COMMISSION DIRECTIVE 2006/27/EC

of 3 March 2006

amending for the purposes of adapting to technical progress Council Directives 93/14/EEC on the braking of two- or three-wheel motor vehicles and 93/34/EEC on statutory markings for two- or three-wheel motor vehicles, Directives of the European Parliament and of the Council 95/1/EC on the maximum design speed, maximum torque and maximum net engine power of two- or three-wheel motor vehicles and 97/24/EC on certain components and characteristics of two- or three-wheel motor vehicles

Figure 1

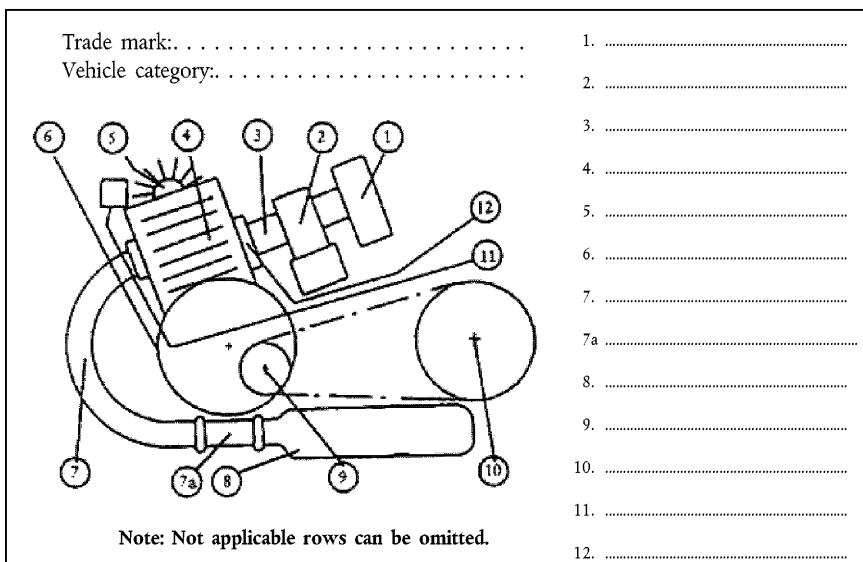
(5) Figure 1 of the Annex to chapter 7 is replaced by the following:
